## MEMORANDUM

**SUBJECT:** OP Report – Minor Modification Request to approved PUD - ZC 06-04E  
1600 North Capitol Street N.W. (Habitable Penthouse Space)

Proposed changes are reflected in the submitted plans (Exhibit 8, Sheets A-3.7 through A-3.8A) as shown:

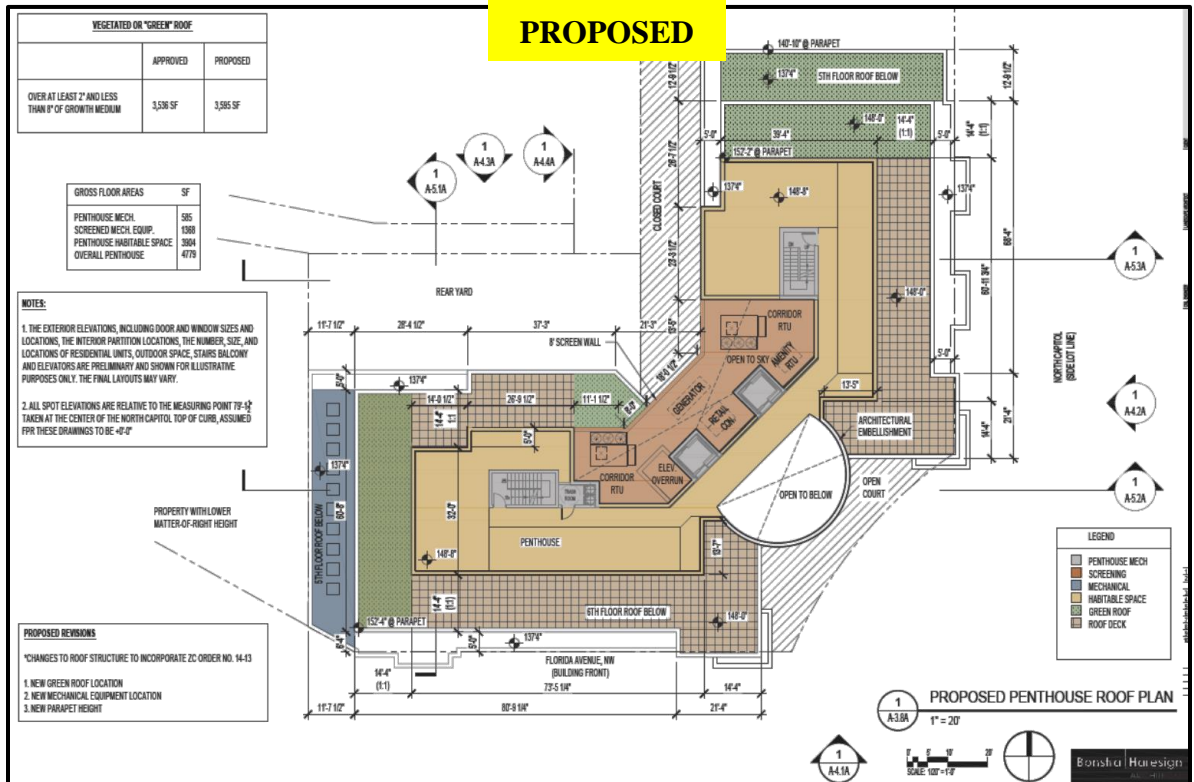
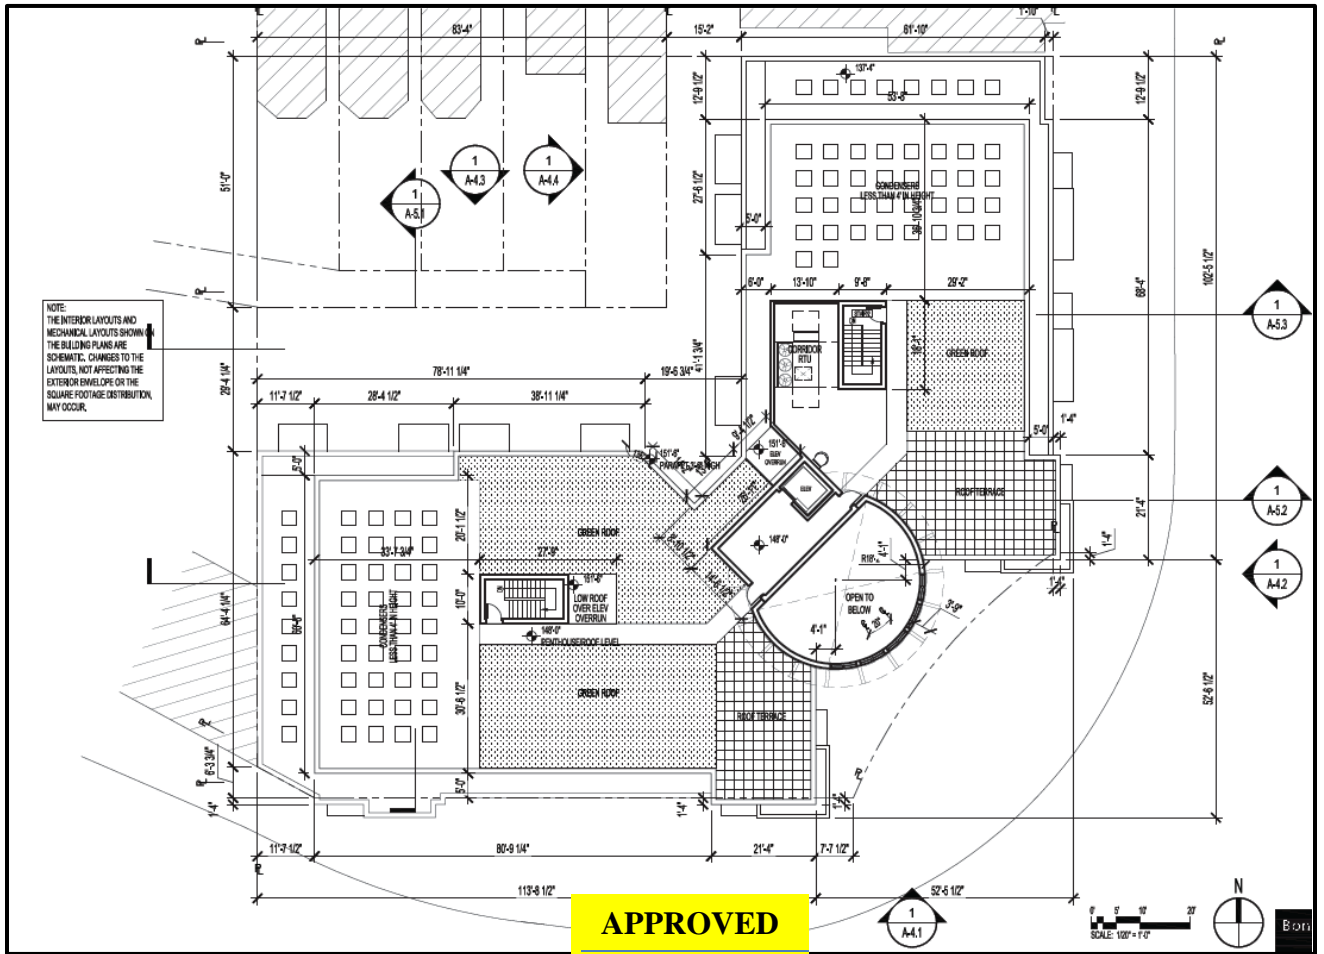
APPROVED PLANS  Sheet A-3.7A	PROPOSED REVISIONS  Sheets 3.7 – 3.8A	OP COMMENTS
<b>Height – 72 ft. 4.5 ins.</b>	<b>73 ft. ½ ins.</b> – Proposed height increase of 8 inches would support the green roof and terrace paving.	This is a negligible change and OP has no objections.
<b>3 separate penthouse structures at a maximum height of 18’ 6”</b>	Habitable Penthouse and mechanical space (egress stairs) – 14 feet 4 inches in height and 8 feet.  Elevator Overruns – 17 feet in height	Conforms to the required setbacks and penthouse height in the C-2-B District and under a PUD.  All penthouse spaces and screened equipment would be placed in one enclosure, in harmony with the main building’s materials and color and consistent with the Regulations.
<b>Unenclosed screened mechanical equipment and unscreened condenser units.</b>	Additional unenclosed screened mechanical units 8 ft. in height;  Unscreened condenser units moved to west wing on 5 <sup>th</sup> floor.	Conforms to the 1:1 setback requirements, except along the back of the northern wing, where 1:1 setback not required from the closed court.

<b>No habitable space</b>	Habitable space to include either new dwelling units or second story of units located on the floor below.	Habitable penthouse space is permitted. The total number of units would not exceed the range of the approved PUD.
<b>IZ/ Affordable housing</b>	Proposed habitable penthouse space = 3,904 sq. ft. (8%= 312 sf). Contribution to the District’s Housing Production Trust Fund to be made in accordance with §§ 414.13 – 414.16, and § 2607.9 ( <a href="#">See Exhibit 1 Page 6</a> )	OP has no objection.
<b>Green Roof - 3,536 square feet</b>	Green roof – 3,595 square feet New locations including on the 5 <sup>th</sup> floor.	The small increase is negligible OP has no objection to proposed changes.
<b>Penthouse Façade Materials</b>	Materials consistent with previous approval – applied horizontally. Penthouse windows would be similar mullion pattern to those of the main building.	OP has no concerns.

<b>Roof Terrace/outdoor recreation space</b>	Proposed with changes in size/area.	OP has no concerns.
